Access Compliance Report

Public Rights-of-Way

Intersection ID: 53893	Main Street: PERTH_MOOR_RD	Cross Street: HAMILTON_BRIDGE_RD	Location: SW
ADA ID: BCBFE5525FC2	Ramp Type: BlendTrans1	Initial Pass/Fail: Fail	Overall Compliance: No
		Severity Score: 8.75

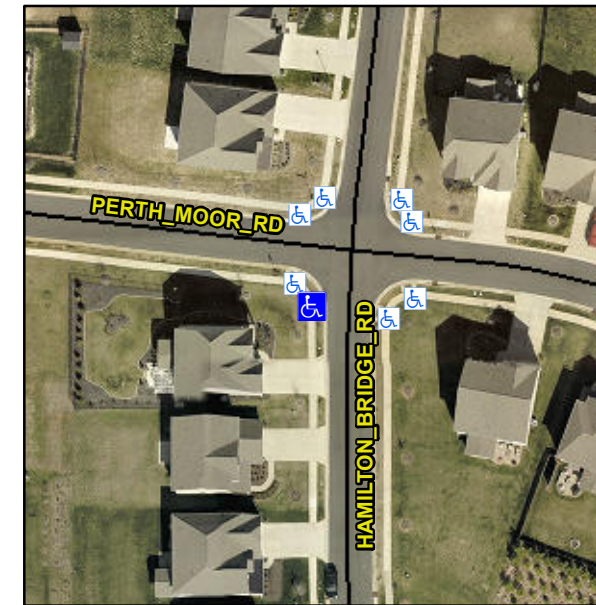
Not Found, R304.5.1

Compliance	Description	Data	Compliance	Description	Data
N/A	Ramp Length (in)	47.0	Yes	BlendTrans Slope (%)	4.0
No	Ramp Width (in)	47.0	Yes	BlendTrans XSlope (%)	1.0
N/A	Flare Type LT	N/A	N/A	Flare Type RT	N/A
N/A	Flare Slope LT (%)	N/A	N/A	Flare Slope RT (%)	N/A
N/A	Flare Traversable LT?	N/A	N/A	Flare Traversable RT?	N/A
N/A	Landing Length (in)	N/A	N/A	DWS Provided?	N/A
N/A	Landing Width (in)	N/A	N/A	DWS Contrast?	N/A
N/A	Landing Slope (%)	N/A	N/A	DWS Length (in)	N/A
N/A	Landing X Slope (%)	N/A	N/A	DWS Full Width?	N/A
N/A	Landing Curb? (Y/N)	N/A	N/A	DWS Offset (in)	N/A
N/A	Shared Landing?	N/A			
N/A	Gutter Ponding?	N/A	N/A	Gutter Slope (%)	N/A
N/A	Gutter Lip Ht (in)	1.0	N/A	Gutter X Slope (%)	N/A
N/A	Painted X Walk1?	No	N/A	Painted X Walk2?	N/A
	X Walk 1 Direction	To E		X Walk 2 Direction	N/A
	X Walk 1 Width (in)	N/A		X Walk 2 Width (in)	N/A
	X Walk 1 Slope (%)	1.1		X Walk 2 Slope (%)	N/A
	X Walk 1 X Slope (%)	1.2		X Walk 2 X Slope (%)	N/A

N/A	Ramp inside XWalk1?	N/A	N/A	Ramp inside XWalk2?	N/A
	Road Slope (%)	1.2		Clear Space?	N/A
	Road X Slope (%)	1.1	N/A	Clear Space to XWalk (in)	N/A
N/A	Any Obstructions?	N/A	N/A	Storm Grate/Utility Hazard?	N/A
	Obstruction Type			Storm Grate/Utility Type	
		N/A			N/A
			Yes	Surface Condition? (G/P)	Good
			No	Curb Slope (%)	11.4

Remove & Replace Curb Ramp With Two New Directional Ramps or Equivalent.
